**RESPONSE TO REQUEST FOR ADDITIONAL INFORMATION**

**US-APWR Design Certification  
Mitsubishi Heavy Industries  
Docket No. 52-021**

**RAI NO.:** NO. 340-2004 REVISION 0  
**SRP SECTION:** 03.08.05 - Foundations  
**APPLICATION SECTION:** 3.8.5  
**DATE OF RAI ISSUE:** 04/21/2009

**QUESTION NO. 03.08.05-14:**

**Figure 1. Loads and secant deformation moduli used in settlement analysis**

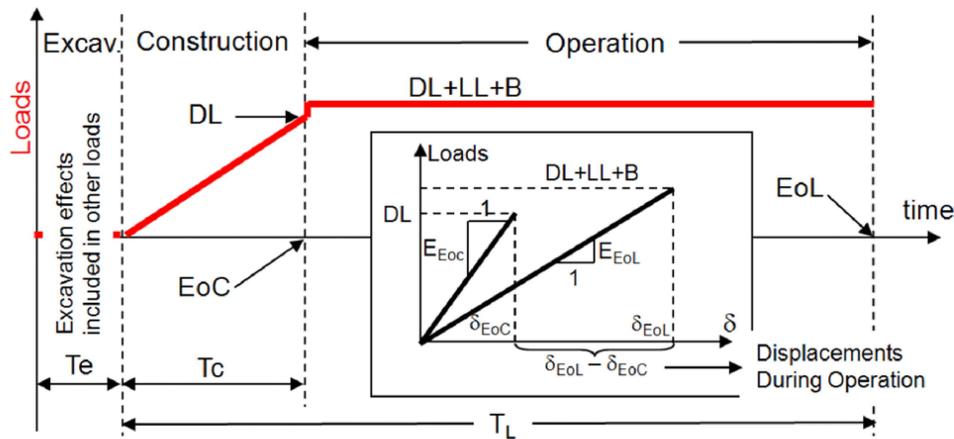
- (1) describe its analytical method used to calculate the settlement and differential settlements of the basemat with respect to the proposed construction sequences, and
- (2) provide the curves of the basemat settlement vs. different stages of construction, and differential settlements of the basemat vs. different stages of construction, for the four types of soil conditions assumed in the DCD.

Use the curves/data provided in response to (2) above to substantiate the claim that "...the basemat is significantly stiffened, minimizing any further tendency of differential settlement."

The settlement analysis considers a generic construction schedule, as follows (Figure 1):

- a) **Excavation.** This phase is assumed to be completed in  $T_e = 6$  months,
- b) **Construction.** The time of construction is taken in the settlement analysis as  $T_C = 38$  months. This represents 44 months from first concrete to fuel filling minus four months for testing (hydro-tests, shakedown, etc.) and an additional two months for major pipe connection lock-in. The reason for excluding 6 months from construction time is explained below.
- c) **Operation.** The operation life of the plant is considered  $T_L - T_C = 60.5$  years, representing 40 years (standard plant commission period), plus 20 years (possible life extension), plus six months removed/eliminated from the construction time that are conservatively added to the operation time.  $T_L$  represents the total life of the plant, including construction and operation - see Figure 1.

The loading scenarios used for each structure along with the corresponding settlements are illustrated in Figure 1. There are different sets of loads acting during the life of the plant that contribute to short term and long term settlements:

The secant moduli for end of construction and end of life are illustrated in Figure 1. They include the effects of both immediate and time dependent deformations produced up to end of construction or end of life and are calculated based on primary consolidation theory and viscous deformation analysis. The total deformations at end of construction at every location in each structure and the subgrade,  $\delta_{EoC}$ , are calculated in a first three-dimensional finite element (FE) analysis using secant moduli at end of construction,  $E_{EoC}$ , and loading during the construction phase. Similarly, the total deformations at end of life at every location,  $\delta_{EoL}$ , are calculated in a second three-dimensional FE analysis using secant moduli at end of life,  $E_{EoL}$ , and loading during operation phase. The deformations produced during the operation life of the plant are obtained as the difference:  $\delta_{EoL} - \delta_{EoC}$ .
